24 November 1981

RE: Raven Service Bulletin No. 113

INSTALLATION OF "PUSH-CHECKS" IN HP-II BURNER PRESSURE GAUGES

FIGURE #1

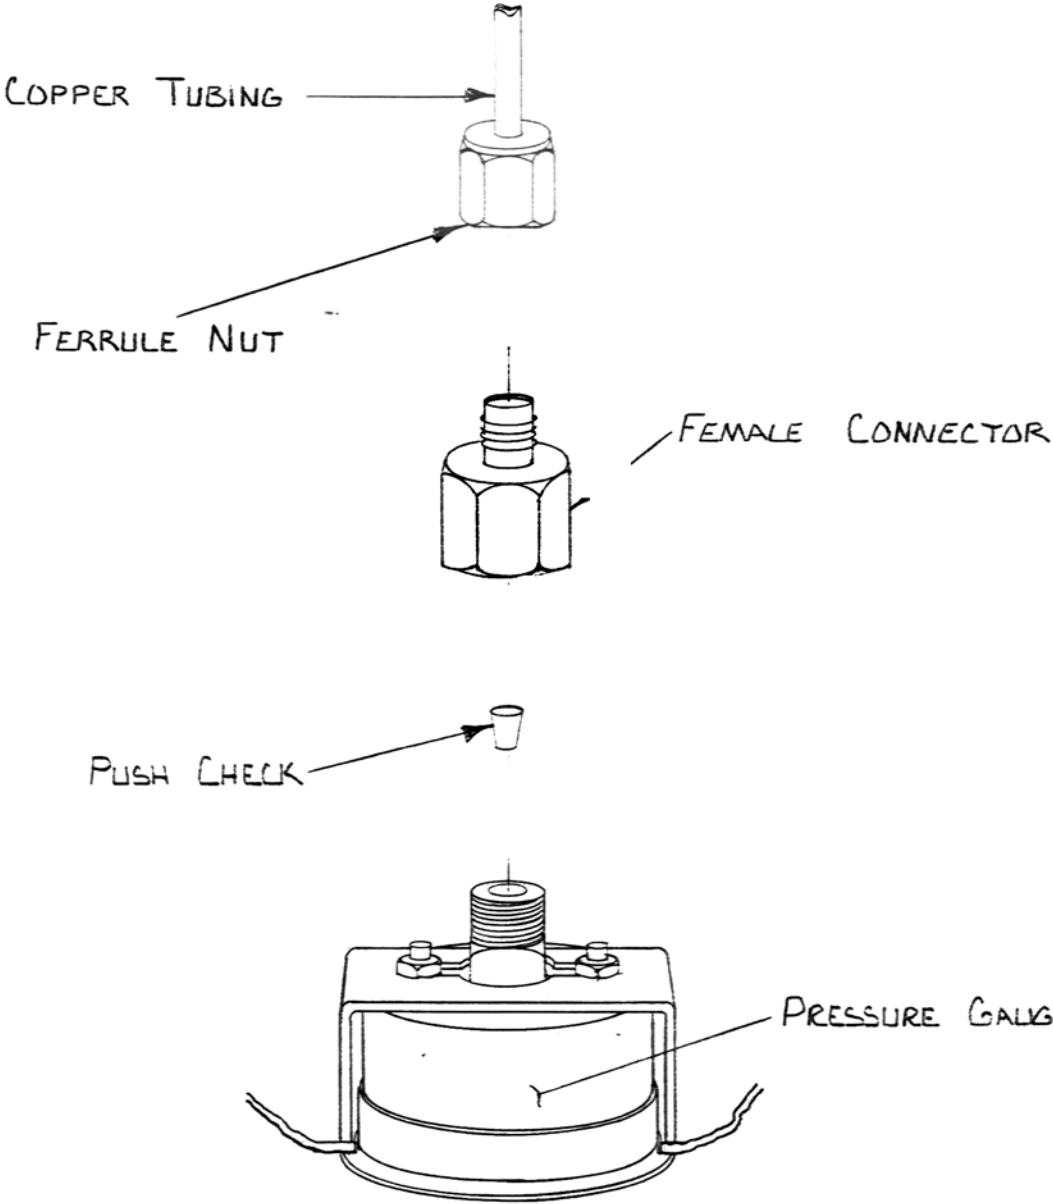
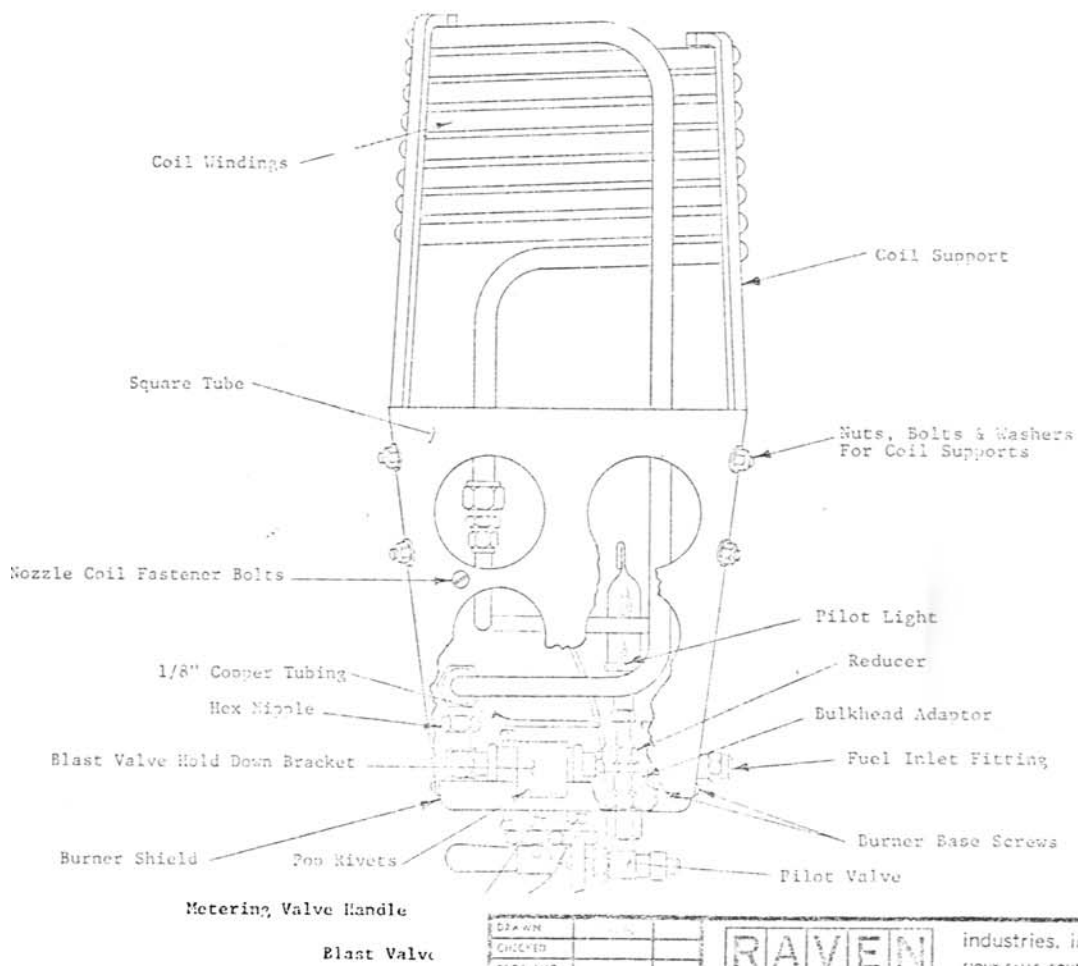
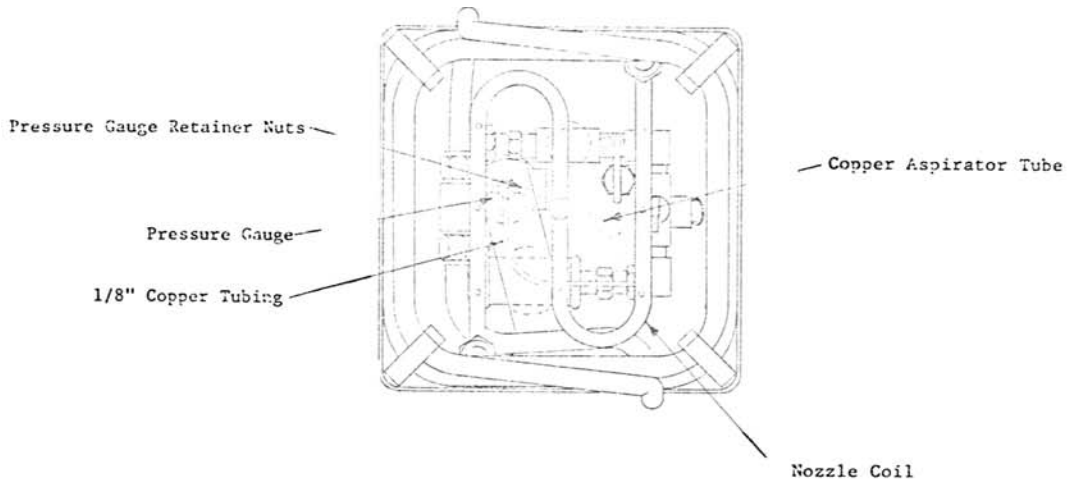
The gauge manufacturer has provided us with tiny brass thimbles which are to be installed in the gauges. These thimbles are called "push-checks" and are to be pressed into the back of the pressure gauges as shown in Figure 1 of this service bulletin. The push-checks have a very small hole in them (.006"), made by a laser beam, which will allow only enough propane movement

The pressure gauge used in the above burners may leak and create a hazardous fire if a solder connection inside the pressure gauge becomes hot enough to become unsoldered. Under normal circumstances, the solder connection temperature is well below the melting point of the solder; however, if there is an existing fuel leak in the plumbing at the base of the burner or if the burner flame is distorted downward as might happen during windy tether operations, the solder connection may have its temperature raised above its melting point. If this happens, the pressure gauge will leak enough fuel that a potentially hazardous fire may result. To eliminate this hazard, a "push-check" should be installed in the burner pressure gauges. The push-check has a very small hole in it which will limit fuel leakage to a non-hazardous level in case the pressure gauge solder connection is melted.

NOTE: Refer to Figure 1 (attached) for component location and identification.

1. Loosen the ferrule nut which connects the 1/8" diameter copper tube to the female connector located on the back of the pressure
-

gauge. Use a 7/16" "crow's foot" attachment and ratchet drive extension on the ferrule nut. Lift the loosened nut off of the female connector, and pull the 1/8" diameter copper tube out of the female connector; it may be necessary to "rock" the 1/8" tube back and forth slightly to do this. Carefully bend the copper tube and ferrule nut to one side. Bend the tube only far enough to allow removal of the female connector and not more than 1".

2. Remove the female connector by using a 9/16" socket and extension.
 3. Position the push-check on the fuel inlet of the gauge as shown in Figure 1. Next, the push-check is to be driven into the inlet. A 1/8" drive punch may be used, but smaller diameter punches must not be used, since these may damage the push-check and defeat its purpose. A proven method is to place the snap-on end of a socket drive extension directly atop the push-check, and then tap lightly on the socket end using a small hammer. The push-check must be at least flush with the top of the opening when installed, and may be slightly recessed (up to about 1/16").

4. Remove the old thread sealant from fittings. Apply new thread sealant to the male threads of the pressure gauge fitting, leaving the first thread free of sealants. Recommended thread sealant is a liquid type with Teflon such as Loctite High Performance Pipe Sealant with Teflon. Because of the location of the pressure gauge, the liquid thread sealant will be easier to apply than Teflon tape. Install the female connector on the back side of the pressure gauge. Avoid overtightening which may distort the gauge housing or shear the gauge mounting screws.

5. Install the ferrule nut and 1/8 inch diameter tube.
 6. Pressurize the burner and inspect for leaks
 7. The repairman must sign the owner's compliance card, including repair station address and forward to Raven for payment.
-
